63 Derry Street/Ledge Road Subdivision Plan

Staff Report

June 12, 2013

Re: Town of Hudson Planning Board Review
Ledge Road Subdivision, 63 Derry Street/Ledge Road
Tax Map 165, Lot 159; PO #1350-821
CLD Reference No. 03-0249.1260

CUL-DE-SAC LANDSCAPE DETAIL

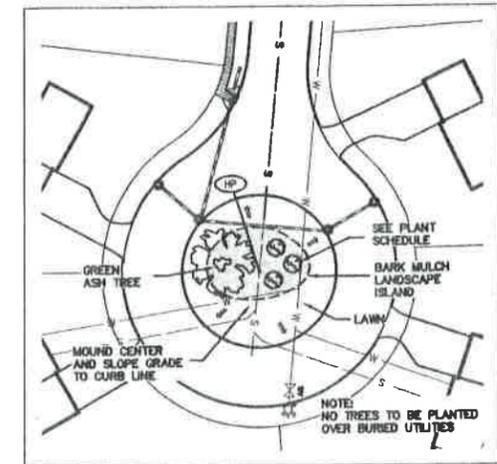
- c. HR 289-18.B.(4) The applicant has not shown an intent of providing landscaping within the cul-de-sac island.
- d. HR 289-18.B.(5) The applicant should provide a "Dead-End" sign location and detail for use at the proposed cul-de-sac entrance. The applicant has provided a stop sign detail; however, we were unable to find the proposed location on a plan view sheet in the plan set.

RIP-RAP GRADATION

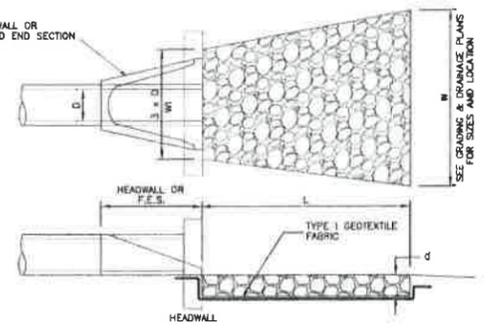
- f. HR 290-4.C. (k) The applicant should illustrate the Pipe Outlet Protection Apron dimensions and thickness on the plan set to correspond with the calculations within the drainage report. We note the detail provided references the Grading and Drainage Plan for size and location; however we are unable to find this information on the plans received for review.

HANDICAP RAMP AT STREET CORNER

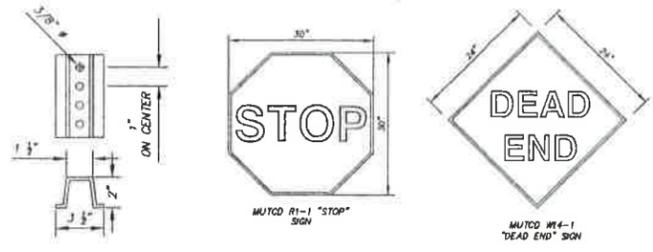
- a. The applicant should revise the American Disability Act (ADA) sidewalk detail to include detectable warning devices for use at the intersection of Ledge Road.

INFILTRATION BASIN OUTLET STRUCTURE

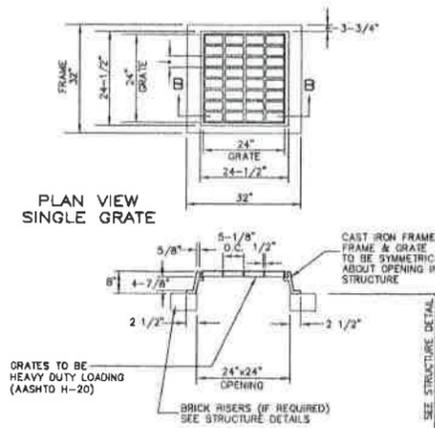
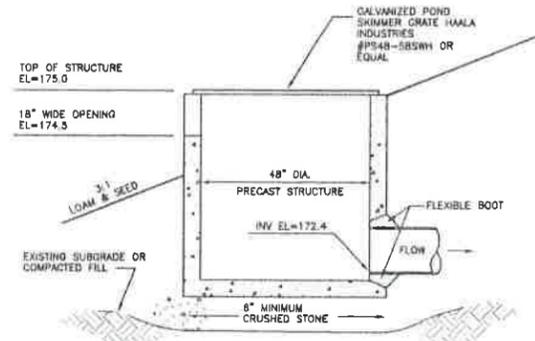
- l. The applicant should coordinate the dimensions of the infiltration Basin Outlet Structure. We note the infiltration Basin Outlet Structure Detail on sheet 9 of 11 illustrates a 48" diameter top grate per noted Haala Industries specifications (#PS48-58SWH), this contradicts the Stormwater Management Report for Pond 2P:X-Basin which shows a 24" horizontal orifice/grate.
